DEPARTMENT OF THE ARMY
NEW ORLEANS DISTRICT, CORPS OF ENGINEERS
P. O. BOX 60267
NEW ORLEANS, LOUISIANA 70160-0267

The purpose of this letter is to respond to questions raised by members of the Environmental Protection Agency (EPA) and some Non-Governmental Organizations (NGO) during the EPA Bayou aux Carpes 404(c) modification request comment period regarding the Gulf Intracoastal Waterway (GIWW) West Closure Complex (WCC) project and the US Army Corps of Engineers' (USACE) request for a modification to the 1985 Bayou aux Carpes Clean Water Act Section 404(c) final determination. The USACE requested a modification to the 1985 Bayou aux Carpes 404(c) final determination to enable construction of the GIWW WCC project, a part of the Greater New Orleans Hurricane and Storm Damage Risk Reduction System (HSDRRS). Some of the comments received questioned the necessity of building a floodwall on the previously impacted spoil bank on the edge of the Bayou aux Carpes 404(c) area and stated that the floodwall could be moved into the waters of the GIWW without consequence. Enclosed is the USACE's response to these comments.

Comparison of Alternatives: Floodwall on shoreline of the Bayou aux

Diagram 1

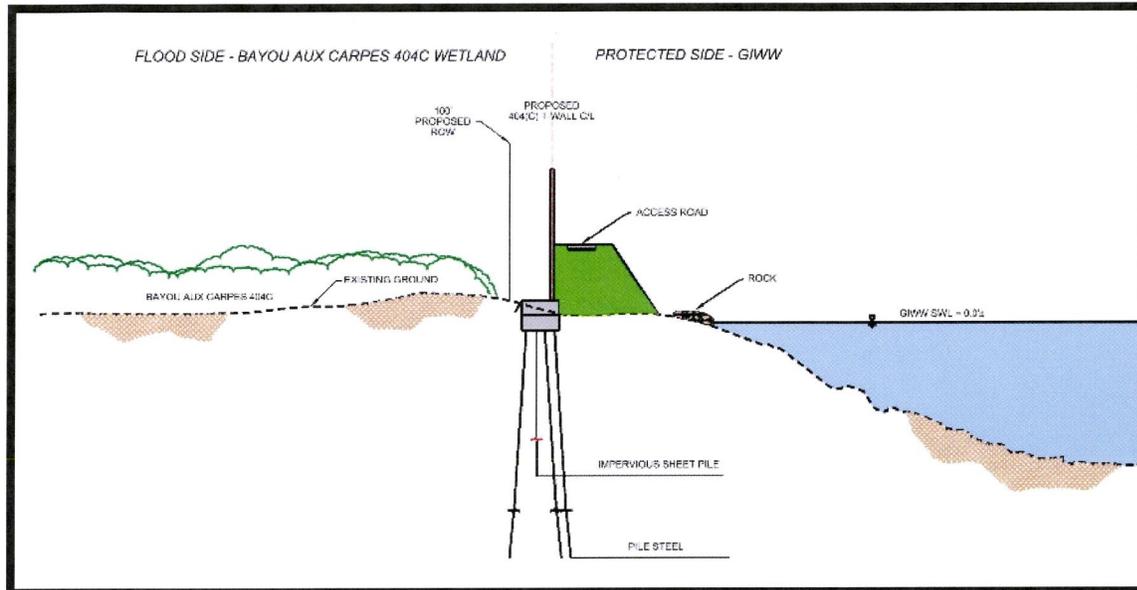
Alternative 1 is the recommended proposed action (see Diagram 1). Under this alternative, the floodwall would be constructed on the previously impacted spoil bank within the Bayou aux Carpes 404(c) area. The design would consist of a T-wall design to minimize the footprint of the structure in the Bayou aux Carpes 404(c) area and foreshore protection using 650 lb stone in the GIWW adjacent to the Bayou aux Carpes 404(c) area. The T-wall would tie into the proposed flow control structure at the end of the Old Estelle Outfall Canal to the north and the closure and pump station complex that would cross the GIWW to the south. The T-wall would be constructed within the 100 ft by 4,200 ft corridor along the eastern edge of the Bayou aux Carpes 404(c) and include an earthen berm with an access road for maintenance and inspection purposes. The floodwall would be a cast-in-place reinforced concrete T-wall designed to elevation +16.0 ft (NAVD 88 2004.65) founded on three rows of steel H-piles. Preliminary design calculations indicate the concrete stem would be 14 ft tall and 2 to 3 ft thick, while the concrete slab would be 3 to 5 ft thick and 20 to 25 ft wide. A continuous steel sheet pile wall will be provided beneath the base slab for seepage cutoff purposes. Construction of the proposed action would impact no more than 9.6 acres within the Bayou aux Carpes 404(c) boundary. The Corps is committed to further reducing this footprint to the greatest extent practicable during the final design phase of this project.

With this proposed action, protection of the wall from potential barge impacts would be provided by the earthen berm and access road along the existing bank line constructed to elevation +8 ft (NAVD 88 2004.65) on the protected side of the floodwall. The location of the wall away from the waterway's edge increases the safety of the wall against potential

catastrophic barge tow impacts by absorbing the energy of the impact in the embankment, thus stopping the tow before it contacts the wall. Placement of the protected earthen berm outside the channel results in no constriction of the waterway as a storm water evacuation route. The reliability of the HSDRRS is highest for this alternative and the potential for damage to the protected side of the floodwall by the daily commercial marine traffic is lessened.

Of the alternatives considered, Alternative 1 provides the greatest navigation safety because it provides greater distance between the floodwall structure and the typical path traveled by barge tows without encroachment or narrowing of the GIWW. It also eliminates the need for other appurtenant structures along the bank which could result in catastrophic impacts including environmental damages to people and the surrounding marsh system should an errant barge tow collide with the pipe pile dolphin protection system.

Diagram 2

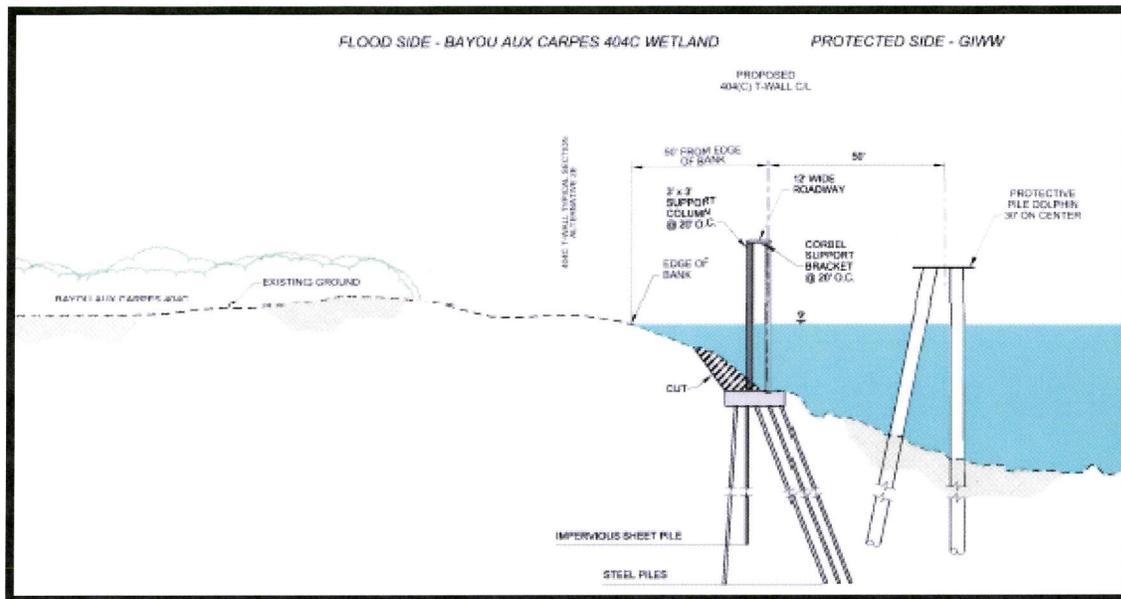
In Alternative 2, the floodwall would be constructed in the water of the GIWW without affecting the surface of the previously impacted spoil bank of the Bayou aux Carpes 404(c) area (see Diagram 2). Preliminary analysis shows that the floodwall would be a cast in-place T-wall designed to elevation +16.0 ft (NAVD 88 2004.65) founded on four rows of steel H-piles. The concrete stem would be 26 ft tall and 3 to 5 ft thick, while the concrete slab would be 4 to 6 ft thick and 25 to 35 ft wide. A continuous steel sheet pile wall would be provided beneath the base slab for seepage cutoff purposes and extended 5 ft past the critical failure plane (elevation -30 ft (NAVD 88 2004.65)) per the latest HSDRRS Design Guidelines. A 12-ft-wide roadway supported by brackets and columns placed approximately 20 ft on center would be incorporated into the design for maintenance access and inspection purposes. The floodwall would be placed in the water of the GIWW 50 ft from the edge of the bank of the Bayou aux Carpes 404(c) area.

A system of pipe pile dolphins would be required to provide a substantial degree of protection to the protected side of the floodwall from daily commercial marine traffic. Based on a preliminary analysis and in accordance with the minimum requirements of the HSDRRS Design Guidelines, a row of about 140 pipe pile dolphins spaced at intervals of no more than 30 ft would be necessary to block vessels from impacting the floodwall. These protective dolphins would be located approximately 50 ft toward the channel from the wall to allow for underground pile clearances. It is important to note, however, that this is only a cursory analysis of required protection based on minimum requirements. Data obtained from the Algiers and Harvey Locks show that vessels traveling through the area weigh as much as 7,800 tons and may be traveling at 8 mph (per Gulf Intracoastal Canal Association). Impact forces calculated from the American Association of State Highway and Transportation Officials (AASHTO) Commentary for Vessel Collision Design show that impacts on the dolphins required in Alternative 2 could be significantly higher than those specified by the minimum design criteria. As a result, the

Alternative 2 does have the greatest potential for catastrophic human and environmental impacts from a spill that could be caused by a barge tow impacting the dolphin system and floodwall. Safety is of particular concern with this alternative which has been determined to be unacceptable to the US Coast Guard (USCG). The pipe pile dolphins constructed in the GIWW to provide floodwall protection would be exposed to the frequent barge tows that travel the waterway on a daily basis. The contents of navigation traffic in this area consist of many hazardous materials, and a collision impacting the wall and its protective structure creates the potential for severe negative environmental impacts on the sensitive 404(c) ecosystem, and surrounding businesses and residents. Both, the USCG, the federal agency responsible for navigation waterway safety, and the Gulf Intracoastal Canal Association representing the waterway users have expressed serious concerns on the severe navigation safety hazard presented by this alternative. As stated by Mr. Raymond Butler of the Gulf Intracoastal Canal Association in an e-mail to EPA, dated February 18, 2009, "This portion of the GIWW is one of the highest traveled reaches of the waterway, moving over half the total tonnage of the entire 1,300 mile long waterway. Nearly 70 million tons per year of petroleum, petrochemicals, chemical products and other bulk freight are moved on the waterway here. Most of this cargo is hazardous in nature and would pose significant environmental risk to this area should a barge incident be incited by the presence of this floodwall and its associated restrictive structures. Risks to navigation safety, the environment, and the public would be unnecessarily increased due to the presence of the supporting structures required by the proposed design change."

Construction of the floodwall in the channel under this alternative is more complex than the other alternatives considered. The proposed construction would be accomplished by means of an extensive internally-braced cofferdam system requiring unwatering of the cofferdam to provide a dry working area for the construction of the T-wall. Additionally, because the cofferdam would be in the proximity of the navigation channel, a barge protection system would be necessary to ensure the safety of the workers. This protection system would consist of the permanent dolphin system or a flexi-float barge system equipped with energy absorption devices. The protection system would need to be constructed prior to commencing work on the T-wall construction within the cofferdam, pushing out the construction schedule significantly. Also, even with a substantial protection system in place, there will remain some risk of a major barge impact into the cofferdam causing a catastrophic loss of life of those working within the cofferdam. Construction within the cofferdam would be staged from floating plants, greatly increasing the construction duration. The cofferdam would be removed upon completion of the floodwall.

Diagram 3

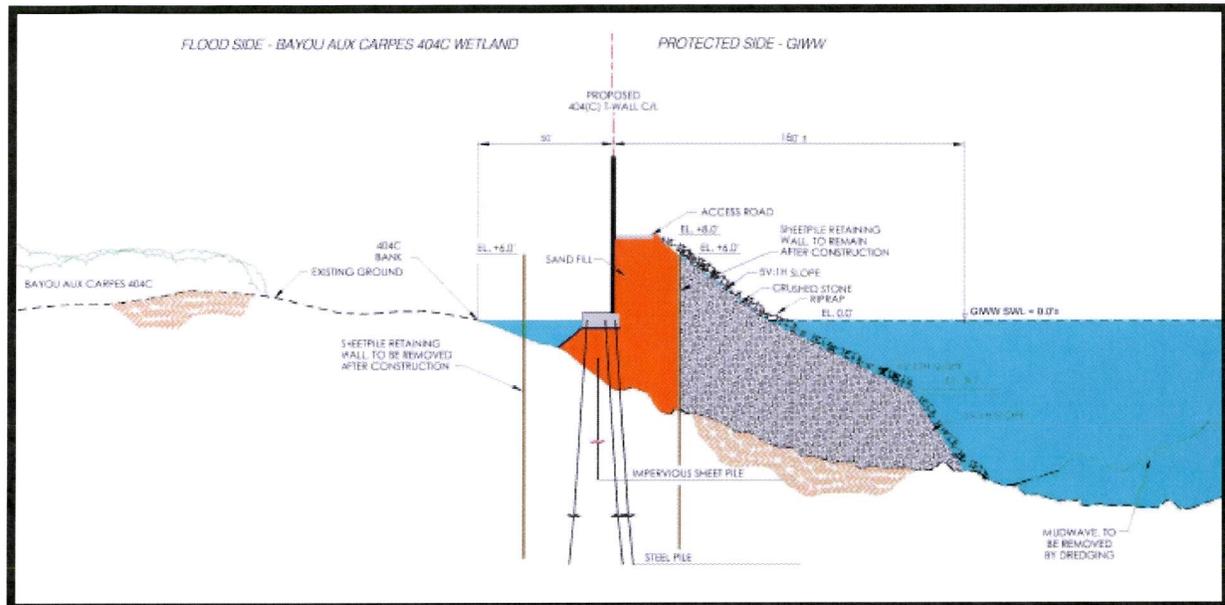
Alternative 3 would be constructed on a man-made sand/stone embankment constructed in the GIWW along the eastern edge of the Bayou aux Carpes 404(c) area without affecting the surface of the previously impacted spoil bank of the Bayou aux Carpes 404(c) area (see Diagram 3). Like Alternative 1, a floodwall would be continuously protected from potential barge impacts by the man-made embankment. The floodwall would utilize a similar design as Alternative 1 and be a cast in-place T-wall designed to elevation +16.0 ft (NAVD 88 2004.65) founded on three rows of steel H-piles. Additional forces imposed on the piling from the embankment placed in the water will require that the steel H-piling be substantially increased in length from Alternative 1 for each of the piling driven. The concrete monolith would be similar to Alternative 1. A continuous steel sheet pile wall would be provided beneath the base slab for seepage cutoff purposes. The man-made embankment on the channel side of the wall would consist of sand fill placed between the T-wall and a separate sheet pile retaining wall, while a "67" type gradation of stone would be used for the embankment on the channel side of the sheet pile retaining wall. A minimum 2,200 lb stone cover would be placed over the "67" type gradation stone and sand to prevent erosion. Once the structure is complete, additional lifts of the 2,200 lb stone would be necessary to maintain the embankment design elevation. Because of the substantial amount of fill being placed in the channel, additional engineering analysis and modeling would be needed to quantify the potential for long term settlement, differential settlement, and lateral movement of the soil. Experience and knowledge in working in similar geomorphologic conditions indicates that the potential movement and/or settlement of materials could jeopardize the integrity, stability, and safety of the HSDRRS, and poses an unacceptable risk to the reliability of the project.

404(c) area, it does have additional environmental impacts not present in Alternative 1. Construction of the man-made embankment in the GIWW would require the relocation of the channel further to the east from the Old Estelle Outfall Canal approximately 2,000 ft south towards the intersection with the Algiers Canal. This shift would be necessary for navigation as well as to maintain the cross section of the existing channel. The relocation of the channel would require the dredging of the Hero Cut. This dredging would have direct and permanent impacts on the island at the intersection of the Algiers and Harvey canals. Additionally, the material dredged from this area would be suspect due to the proximity of a barge cleaning and painting operation just across the canal. Based upon preliminary investigations by the Corps, this island is considered to pose a high risk of containing contaminated or hazardous substances due to the industrial complexes that have been operated in the area for years. Additionally, there are a number of abandoned barges in this area that are likely to pose a risk of contamination if disturbed. It is the policy of the United States Government to avoid areas that contain Comprehensive Environmental Response, Compensation, and Liability Act (CERCLA) (formerly known as Superfund) regulated substances. Furthermore, the clean up of any hazardous substances would be the responsibility of the State of Louisiana acting as the non-Federal sponsor for this project. The disturbance of this site would likely lead to an extended delay in the construction of the project, thus delaying hurricane and storm damage risk reduction for the people of the West Bank for many more years. Augmentations in the Bayou aux Carpes 404(c) area would not be required for Alternative 3 since no impacts the 404(c) area would occur.

Construction of the floodwall in the channel under this alternative is more complex than Alternative 1, but has fewer complexities than Alternative 2. Construction would begin with the dredging necessary to establish the new navigation and drainage channel. This would be contingent upon environmental soil sampling and a determination that the material would be suitable for normal dredge material disposal. Construction of a cofferdam approximately 100 ft from the existing bank line of the 404(c) area would closely follow the relocation of the channel. The cofferdam would be similar to the cofferdam proposed for Alternative 1. Sand would be placed in the interior of the cofferdam to elevation+2.0 ft (NAVD88 2004.65) while small stone would be placed on the exterior of the cofferdam to elevation+2.0 ft (NAVD88 2004.65) to stabilize the cofferdam wall. Because of the weight of sand and stone that would be placed, a considerable amount of consolidation and lateral spread of the underlying soft, organic soils would occur, creating a "mud wave" within the GIWW. Additional dredging will be necessary to remove this "mud wave" during placement of the sand and stone material to maintain the authorized navigation channel. Because of the consolidation and lateral spread, multiple additional lifts of sand and stone would be necessary to stabilize the material at elevation+2.0 ft (NAVD88 2004.65) so that construction of the T-wall could commence. As with Alternative 2, because the cofferdam would be in the navigation channel, a barge protection system would be necessary to ensure the safety of the workers. This protection system would consist of a protective dolphin system or a flexi-float barge system equipped with energy absorption devices. The protection system would need to be constructed prior to commencing work on the T-wall
